AT Option 1

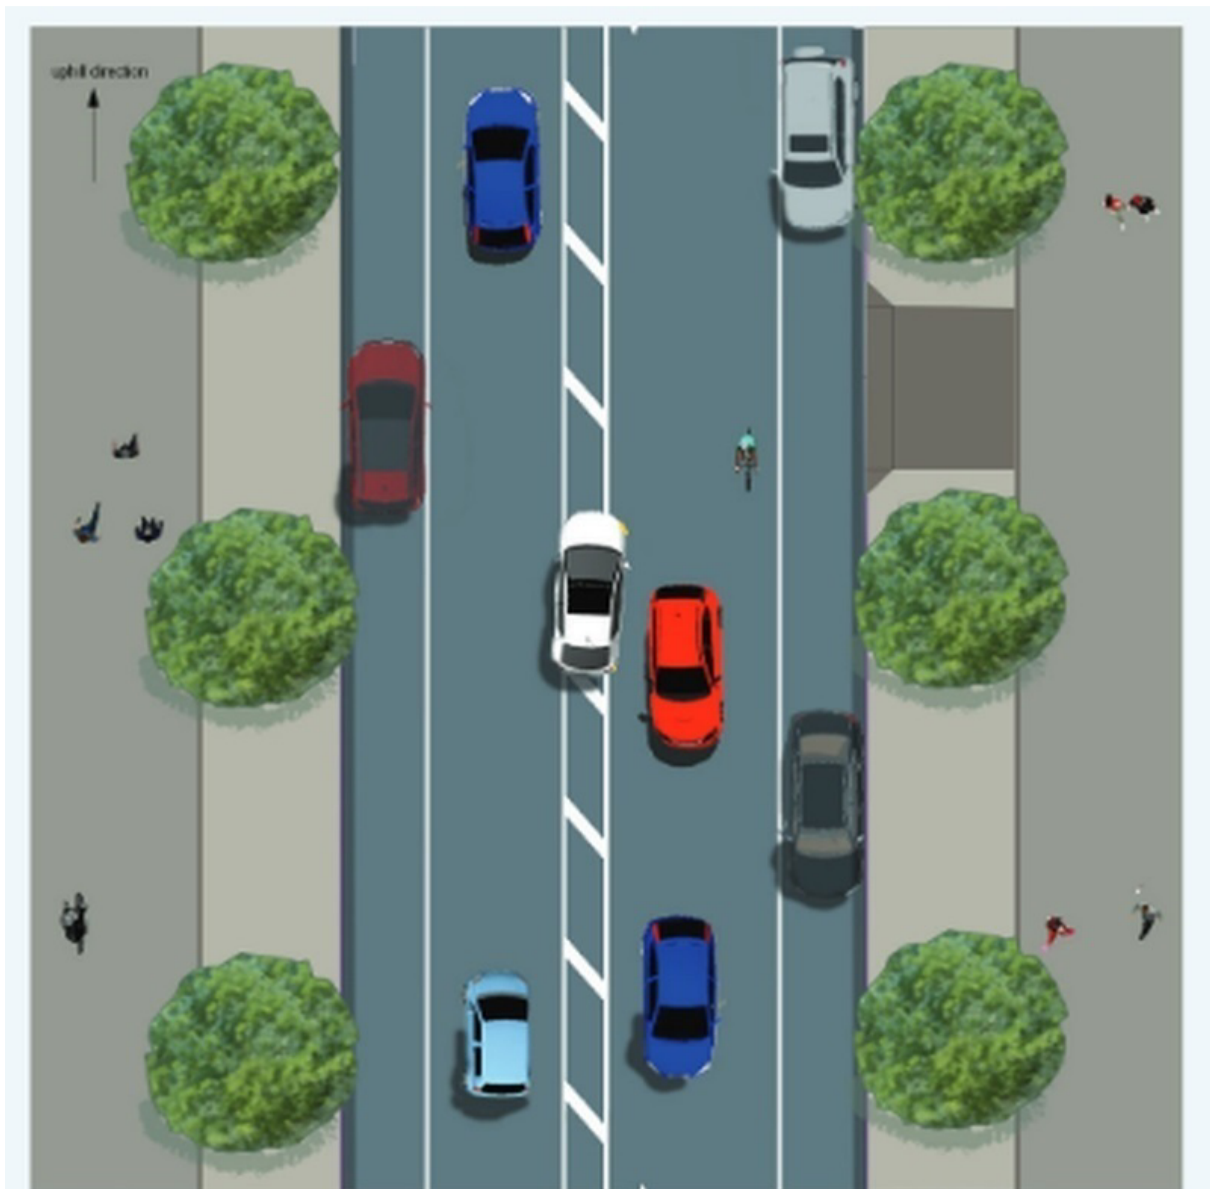
Key concern: No separation between pedestrians and cyclists uphill - faster cyclists not catered for well, even slower cyclists will conflict with pedestrians. No priority across side roads.

Key concern: No separation from between vehicles and downhill cyclists - will feel unsafe for novice cyclists

Key concern: Design actually adds significant car parking above existing (current parking interrupted by trees)

AT Option 2

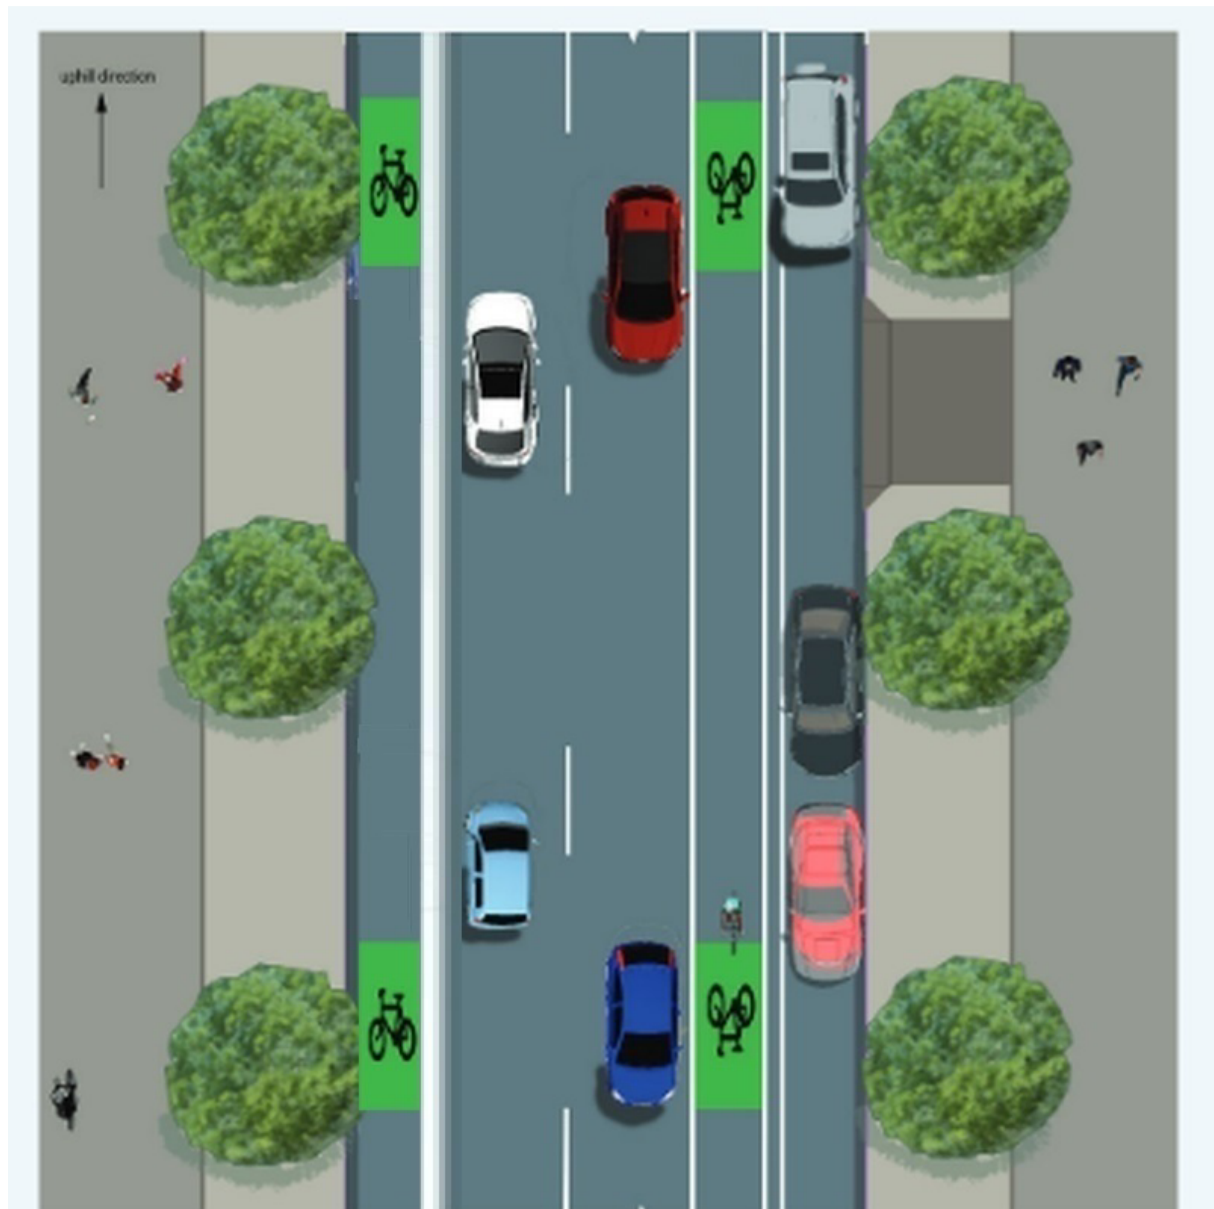
Key concern: Uphill issues as per Option 1

Key concern: No facilities downhill - even more unattractive for general population who would like to cycle

Key concern: Median encourages drivers to wait in it before turning right - but this will push southbound drivers to the right, in turn forcing cyclists into the door zone of the parked cars

Key concern: extra parking added as per Option 1

CAA Cycle Lane Option 1

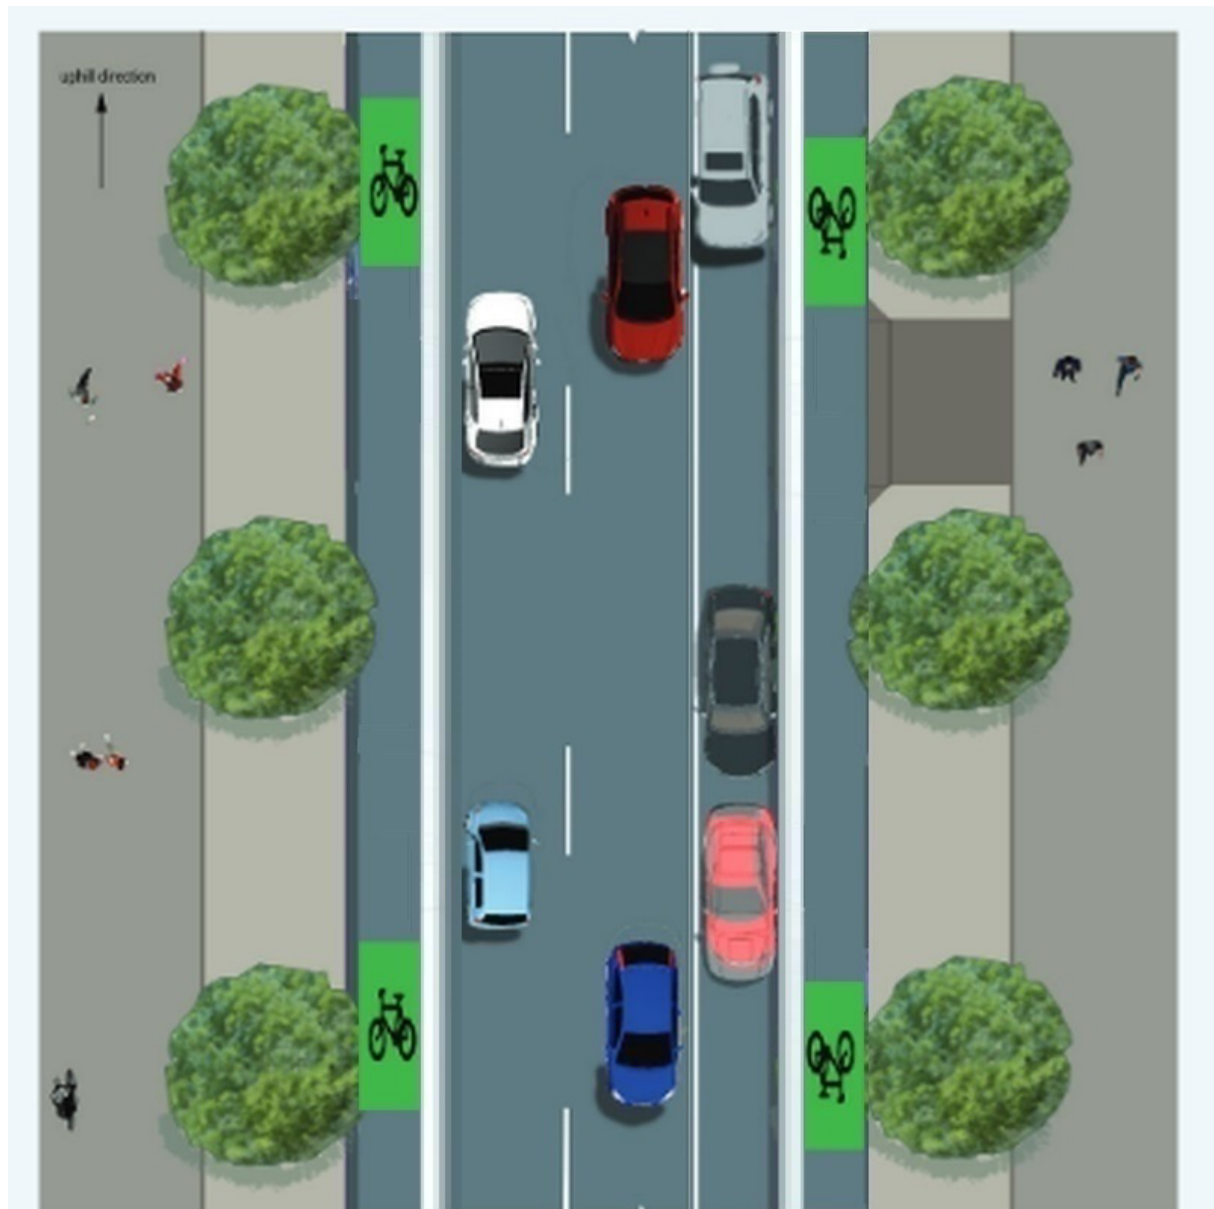
Remove uphill car parking and provide a protected cycle lane (likely a 2m wide Copenhagen lane, i.e. half-height kerb above than car lane)

Provides significantly improved uphill convenience and safety, and removes conflicts of having to share with pedestrians.

Downhill issues remain.

Overall car parks likely somewhat below existing Franklin Road levels (but possibly not much less, as will have more eastern car parking than now)

CAA Cycle Lane Option 2

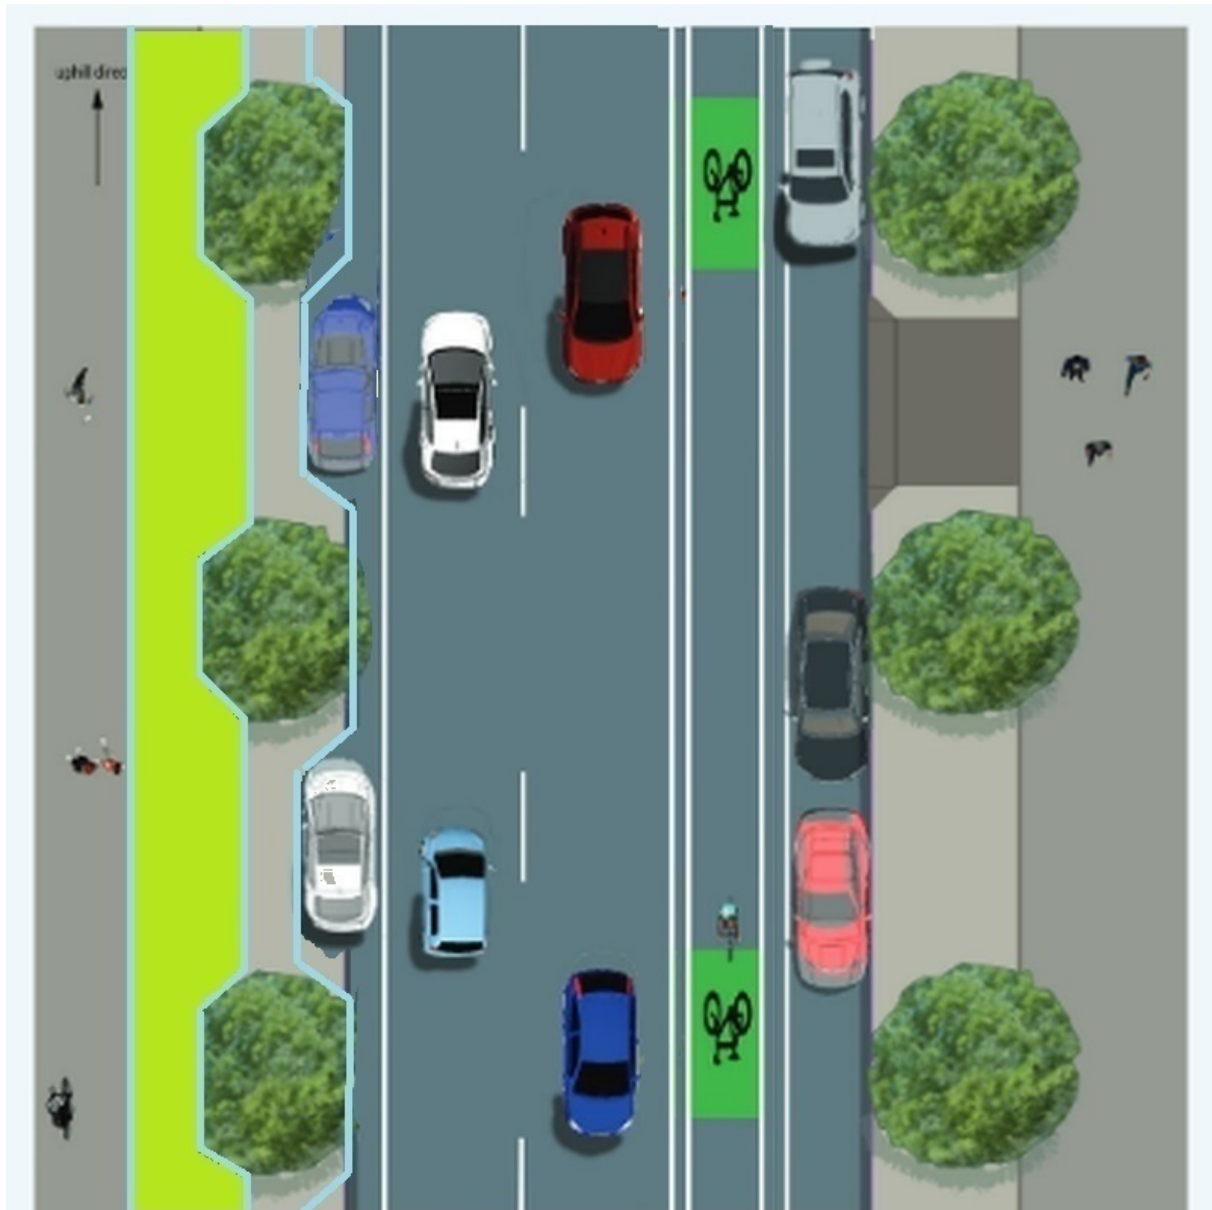
Provide a downhill protected cycle lane behind parking.

However, uphill cycle lane will need to be very narrow to allow downhill cycle lane to be safe from door opening. Likely can't provide full compliant protected lanes both sides and keep even a single parking lane & trees.

Would reduce car parking on Franklin Road significantly below current levels, as parking would have to be banned for extra distances at each driveway (guidelines vary but tend to recommend several metres extra each driveway to give drivers / cyclists time to react).

CAA Cycle Path + Cycle Lane, Option 4

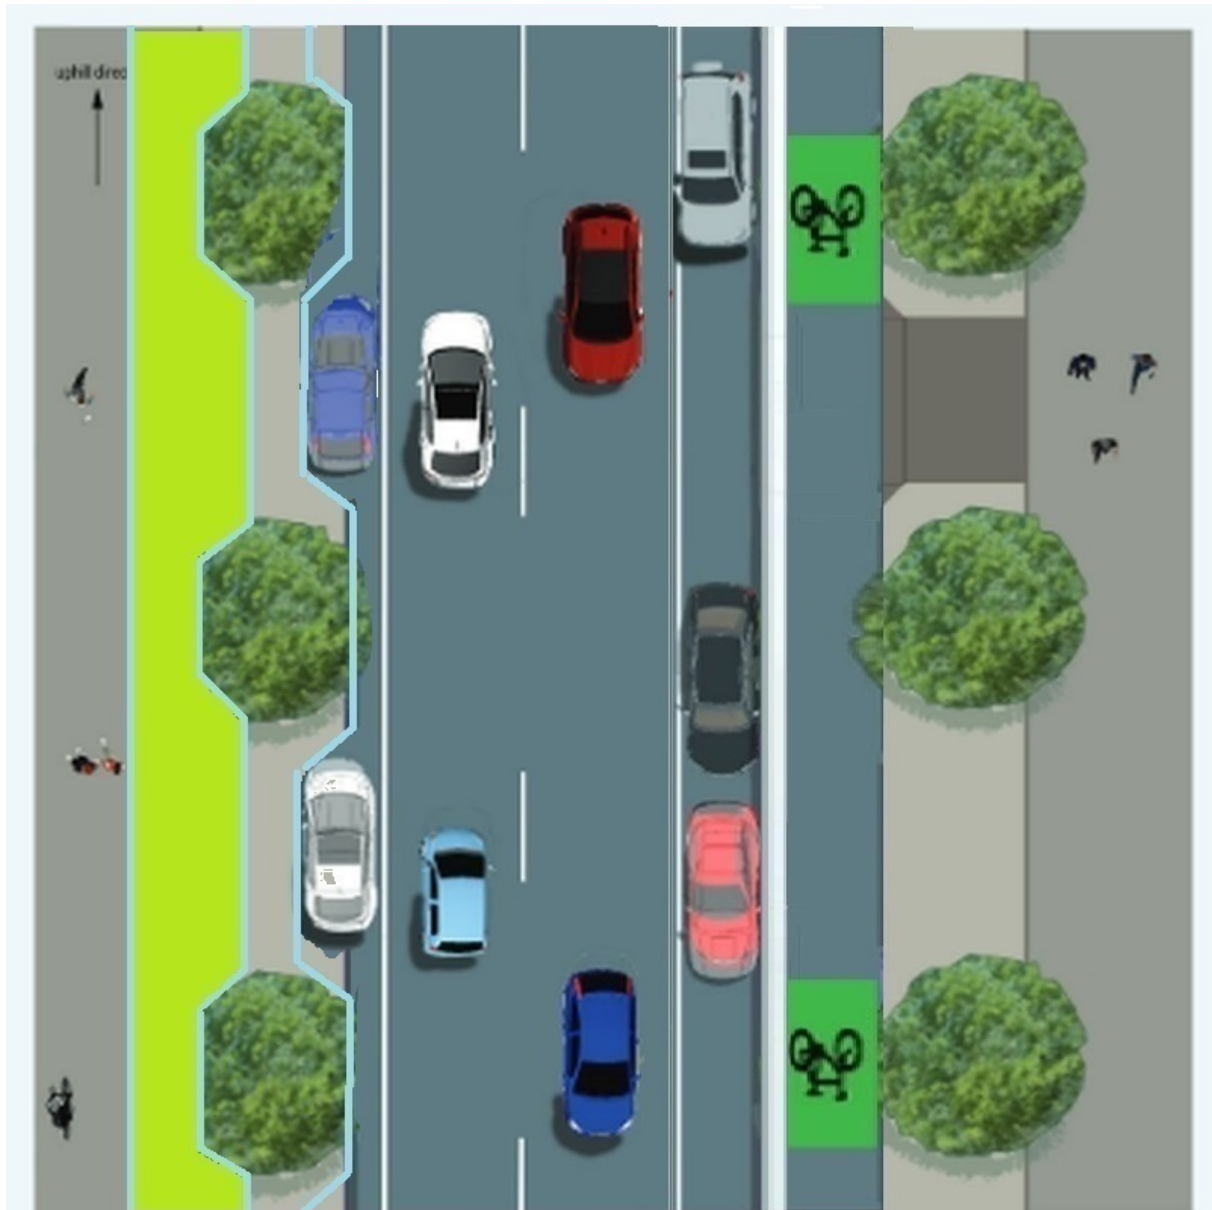
As CAA Option 3, but indent western-side parking. Use the extra width gained to provide greater door buffer zone for downhill, and provide an additional buffer to cars on other side of downhill lane (~3m total width).

Indented car parking formed so as to protect tree roots.

Overall likely to be same or slightly higher number of car parks than exist now (net gain) and retains parking both sides.
